Finding of Suitability to Transfer for Parcel A (Revision 3)

Hunters Point Shipyard
San Francisco, California

- 1 Revised Responses to Agency Comments on the Draft Finding of Suitability to Transfer for Parcel A, Dated November 6, 1998
- 2 Revised Responses to Agency Comments on the Draft Final Finding of Suitability to Transfer for Parcel A, Dated September 22, 1999

- 3 Responses to Agency and Public Comments on the Finding of Suitability to Transfer for Parcel A, Revision 2, Dated March 26, 2002
- 4 Resolution of the Responses to Agency Comments on the Finding of Suitability to Transfer for Parcel A, Revision 2, Dated August 26, 2002

FIGURE 1
SITE LOCATION MAP

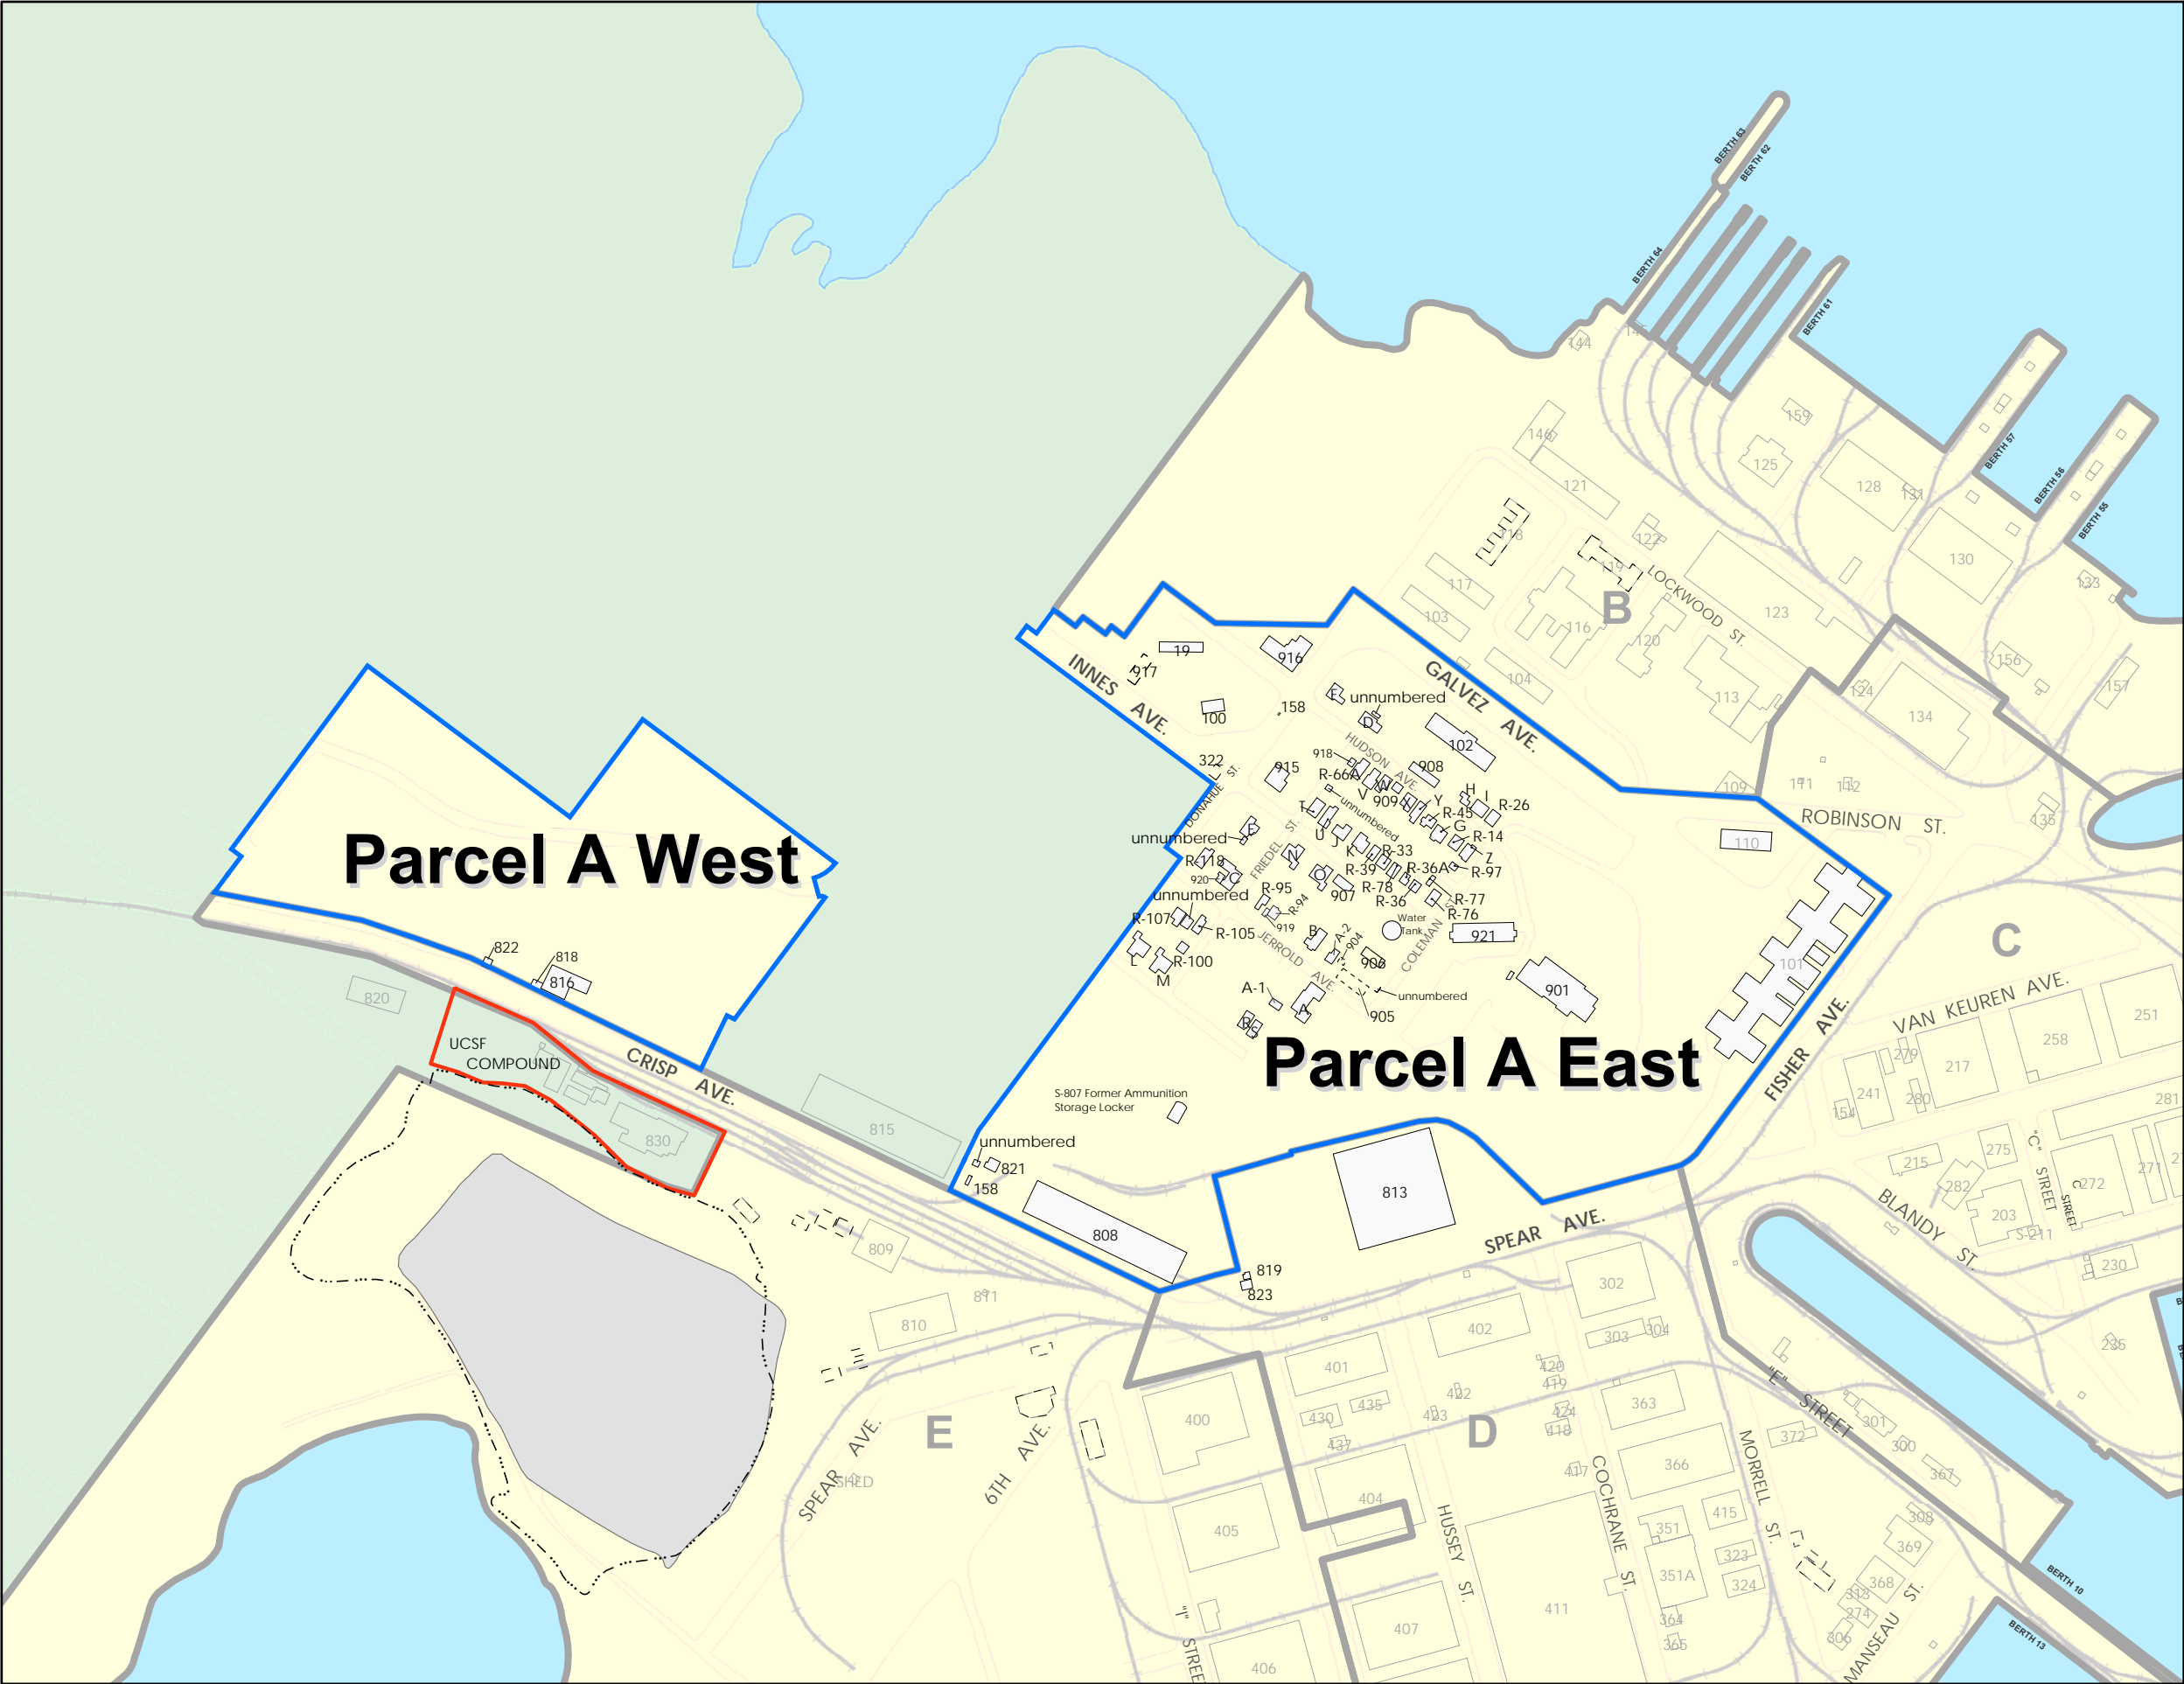
4. Comment: Figure 1, Boundary Map

Response: Figure 1 has been revised to make the boundary lines heavier ; this figure number has been changed and is designated Figure 2 in the final Parcel A FOST. This figure is a reduction of a full-size boundary map. The Navy will provide the SFRA with a copy of the full-size boundary map upon request.

FIGURE 2
PARCEL A MAP

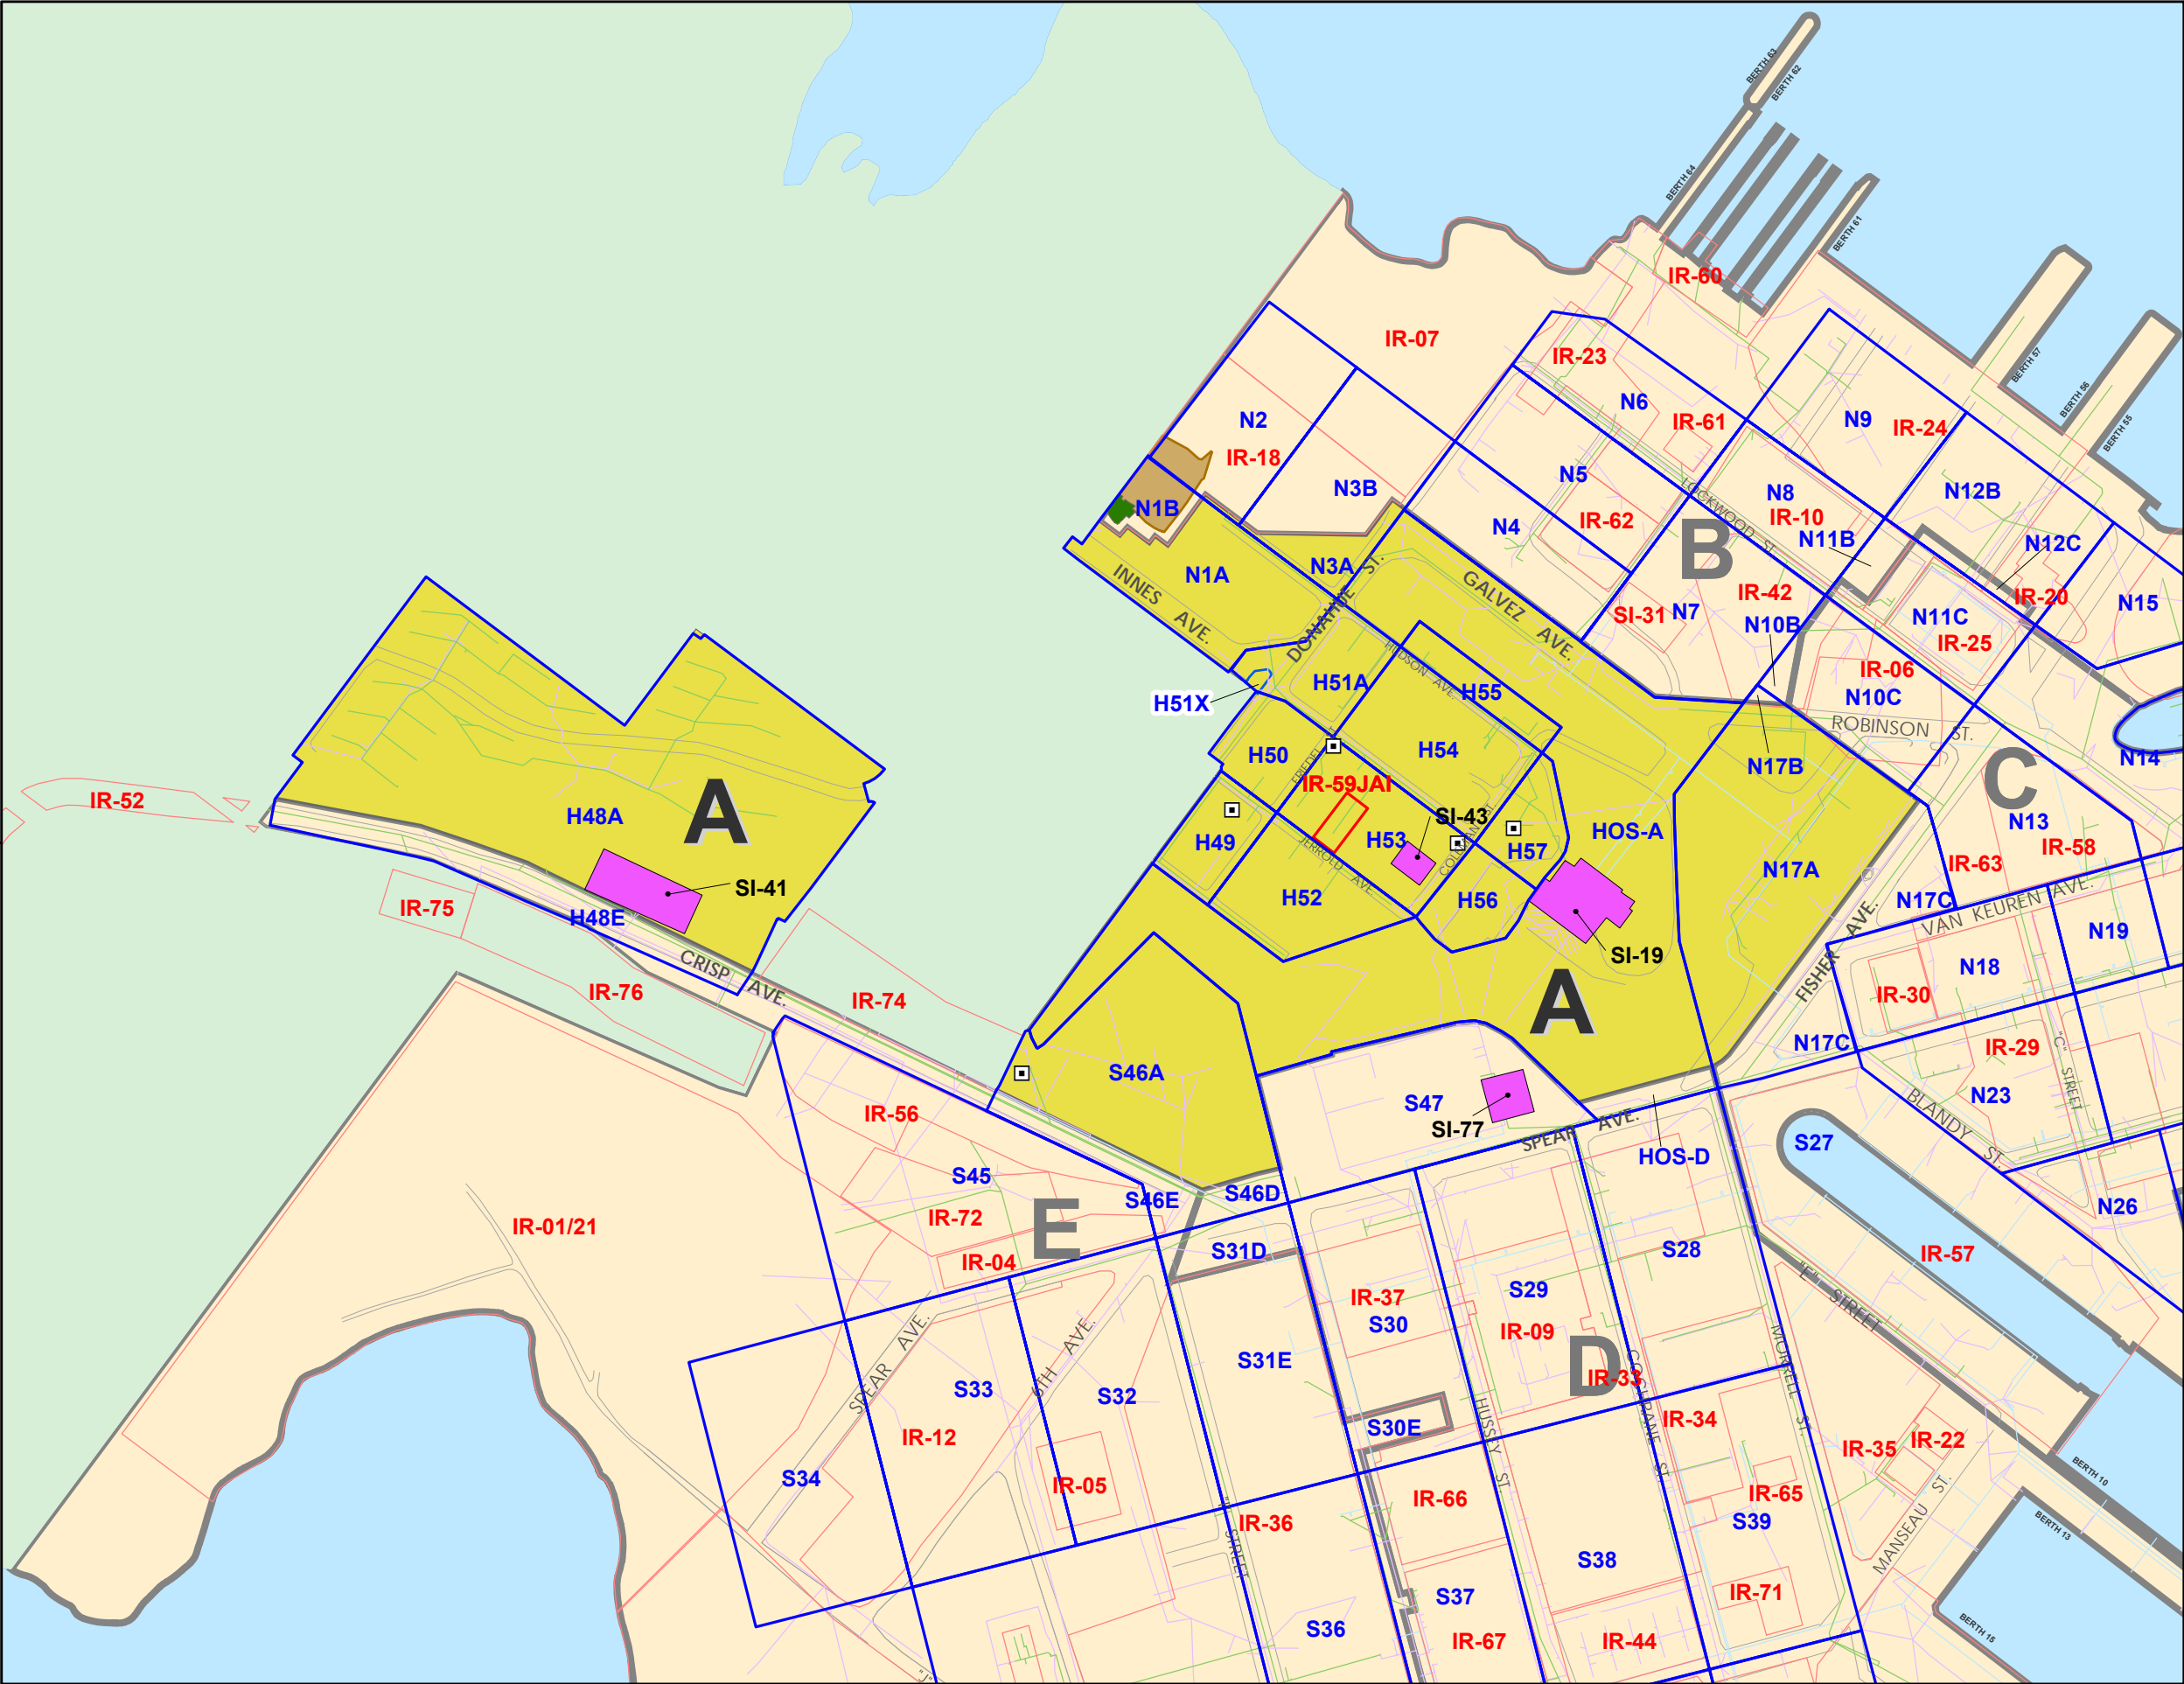
16. **Comment:** **Figure 2: Identify the [Water?] Tank to the northeast of Building 906 and locate Pump Station A.**
- Response:** The Navy will revise the FOST accordingly.

3. **Comment:** **Section 2.0 Property Description:** The text states that, “Currently, 64 buildings are present on Parcel A...” However, 70 buildings are shown on Figure 2. Also, the number of buildings on FOST Figure 2 does not agree with the number of buildings shown on ROD Figure 3: for example, three additional buildings in Parcel A West are shown on ROD Figure 3 and Building 818 is not shown. Please clarify the number of buildings that are included in this FOST (and which are on Parcel A).

19. **Comment:** **Figure 2:** Please include/label the following buildings (some of which are listed on Table 1): Building 158, R-66A garage, R-105, T garage, small unnumbered building adjacent to R-107, small unnumbered buildings adjacent to D and E, unnumbered building in H53, two small unnumbered buildings west of Building 821, and one small unnumbered building west of Building 901.

- a. Include transformer sites in S46A, H49, H53, H57 and electrical substations.**
- b. H-49. Include R-106 and the building (Figure 2) adjacent to R-107. Also: R-105 is not shown/labeled on Figure 2.**

- c. H-50. Include small building adjacent to E.**
- d. H-51. Building 158 is not shown on Figure 2.**
- e. H-53. Unnumbered residence not shown on Figure 2.**

- f. H-54. R-66A and T garages are not labeled on Figure 2.**
- g. HOS-A. The subparcel designation for Buildings F, 102 and 901 should be HOS-A (not H-OS) to be consistent with Figure 3.**

Response: Based on map reviews and site observations, Figure 2 has been revised to show total of 72 existing buildings in Parcel A. Figure 3 of the ROD shows small structures north of Building 817 and west of Building 816 in Parcel A West, which are not shown on Figure 2 of the FOST. Based on interpretation of recent aerial photographs, Figure 2 of the FOST has been revised to show buildings in Parcel A West, including 816, 817, and 818. In addition, the number of buildings in the text in Section 2.0 has been revised to refer to a total of 72 buildings located within Parcel A, including the water tank.

Response: [Figure 2](#) has been revised to include labels for Buildings 158, R-66A garage (labeled as 918), R-105, and T garage (labeled as unnumbered). In addition, the following buildings were labeled as unnumbered: small buildings adjacent to R-107, D, E, 821, 901, and 905.

- a. A new column, Transformer Sites, has been added to [Table 2](#) to identify subparcels with transformer sites, as shown in the table below.
- b. [Figure 2](#) has been revised to change the label from “R-106” to “R-105.”

- c. The designation “unnumbered building” has been added for H50.
- d. [Figure 2](#) has been revised to show Building 158.
- e. [Table 2](#) has been revised to show the following buildings in H53: 904(d), 905(d), 906(d), 907, 919, A-2, B, N, O, R-94, R-95, water tank, and unnumbered storage cage. [Figure 2](#) has been revised to show the unnumbered storage cage.

- f. [Figure 2](#) has been revised to show a label for the T garage as “unnumbered” and a label for the R-66A garage as “918”. [Table 2](#) has been revised to reflect these changes in H54.

**FIGURE 3
HPS SUBPARCEL UNITS
AND IR SITES**

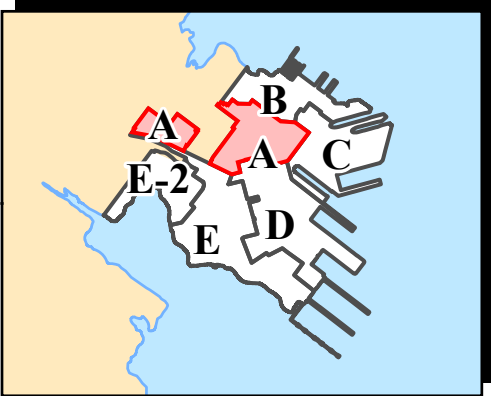
4. Comment: Subparcel N-13A is not labeled on Figure 3.

5. Comment: No streets labeled on Figure 3. Would like to see where Fisher, Spear and Crisp are on the map - like on Figures 2 and 5 of FOST Revision 1.

17. **Comment:** **Figure 3: Identify subparcel N13A and correct the blue line that terminates in N13.**
- Response:** The Navy will revise the FOST accordingly.

4. **Comment:** **Figure 3, HPS Subparcel Units and IR Sites:** Please clean up the map shown in Figure 3. There are many discrepancies between FOST figures 2 and 3 and between the Parcel A ROD and FOST figures with respect to the Parcel A boundary. For example, the yellow area that shows the extent of Parcel A spills onto non-Navy property and may cause confusion as to the extent of Parcel A. Also, Figure 3 shows a portion of IR-18 as present in Subparcel N3A.

9. **Comment:** **Section 5.1.5, Off-Parcel Issues:** Please discuss the soil excavation at IR-18. In some cases excavations at IR-18 ended at the parcel boundary. Further, remediation at other IR-18 excavations near the Parcel A boundary was halted prior to the full removal of contamination and therefore the extent of contamination has not been determined. Because of this, DTSC request that Figure 3 show the locations of IR-18 excavations.

10. **Comment:** **Section 5.1.5, Off-Parcel Issues:** Please show the location of IR-52 and SI-77 (adjacent to Building 813) on Figure 3.

Response: The Navy will revise Figure 3 to identify subparcel N-13A.

Response: The Navy will revise Figure 3 accordingly.

Response: The “yellow area” that spills “onto non-Navy property” is actually included in Parcel A and correctly represents Parcel A. The boundary of Parcel A that contains the subject areas is contiguous with property that is not owned by the Navy, as is shown on [Figure 3](#). This portion of the boundary of Parcel A was delineated directly from legal descriptions and is correct. The boundaries of the environmental baseline survey (EBS) subparcels were established during the original EBS at HPS based on computer-aided design (CAD) drawings of the base that were available when the EBS was prepared. These boundaries were slightly inaccurate. These inaccuracies resulted in the minor differences between the extent of the EBS subparcels and the footprint of Parcel A, as noted by the DTSC comment. Accordingly, the boundaries for EBS subparcels N1A, S46A, and H48A—shown on Figure 3 of the FOST—have been revised to be contiguous with the Parcel A boundary. In addition, the following text has been added at the end of [Section 2.0](#), page 6:

Response: The excavation in IR-18 is discussed in [Section 2.0](#), Property Description. Full characterization and removal were completed in this area. No excavations at IR-18 were halted at the boundary between Parcels A and B. Excavations were not extended into non-Navy property northwest of Parcel B. [Figure 3](#) has been revised to show locations of excavations at IR-18.

Response: IR-52 and SI-77 have been added to [Figure 3](#).
